# 677 W Canfield St – Historic District Commission

Appropriateness Review: HDC2024-00404 – COA Conditions Proposal

# Brick Archway Restoration in Rear – Original

# Archway #1

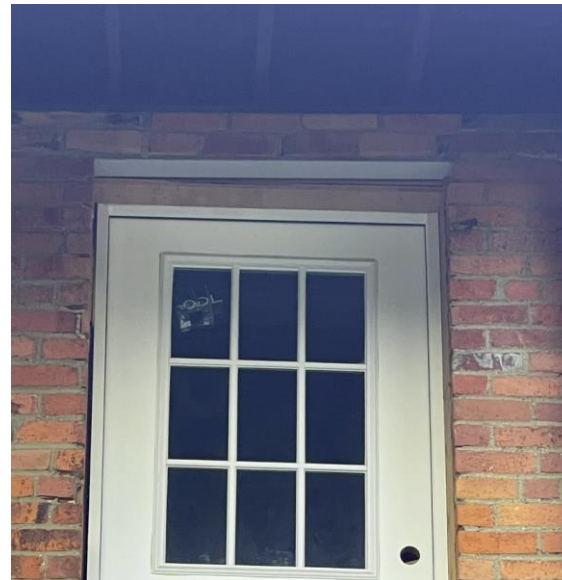
## Challenge:

- Original archway location is partially destroyed by door rough opening
- There is not much brick remaining above the door rough opening

## Proposal 1: Leave as is

**Alternative Proposal 2:** Attempt to install an archway ~2 brick widths higher than original location above current door rough opening
